1984 Corvette: Service Bulletin: Generator Noise (Moan) at Idle with Air Conditioning On

Source: Chevrolet Dealer Service Bulletin

Bulletin Number: 84-151, Section 6D (VIy)

Date: June 1984

FIGURE 1

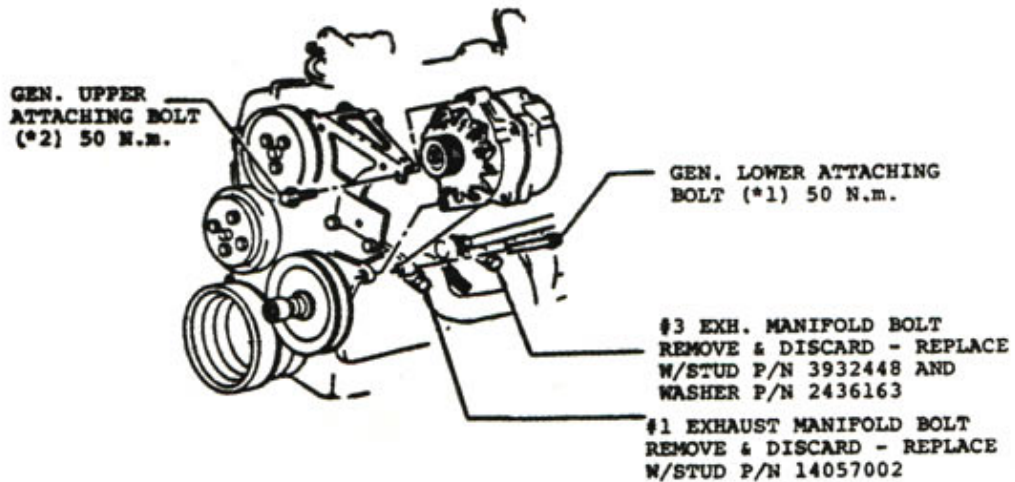
Some 1984 Corvettes may exhibit the subject noise, which is commonly defined as a "moan". This noise is induced into the generator by belt excitation when the air conditioning compressor is "on".

The following service procedure has been developed to reduce this noise by using three (3) new tubular braces and fasteners to replace the generator vibration period, which is the primary noise source.

1. Remove the generator rear support brace. Discard the support brace, attaching nut and attaching bolt.
 2. Remove and discard #1 and #3 L.H. exhaust manifold to cylinder head attaching bolts (see Figure 1).

3. Install stud, P/N 14057002, in place of discarded #1 bolt and torque to 35 N.m.
 4. Install stud, P/N 3932448, and washer, P/N 2436163, in place of discarded #3 bolt and torque to 35 N.m.

- NOTICE: Washer is to be installed on stud between stud hex and exhaust manifold.
5. Remove the serpentine belt from the generator pulley.
 6. Loosen generator attaching bolts (2). (See Figure 1).

9. Mandatory torque sequence (Figures 1 and 2):

- Generator lower attaching bolt 50 N.m.
- Generator upper attaching bolt 50 N.m.
- Long tubular support brace to generator, attaching bolt 35 N.m.
- Two (2) short tubular support braces to generator, attaching bolt 50 N.m.
- Three (2) tubular support braces to three (3) exhaust manifold studs, 25 N.m. three (3) attaching nuts.
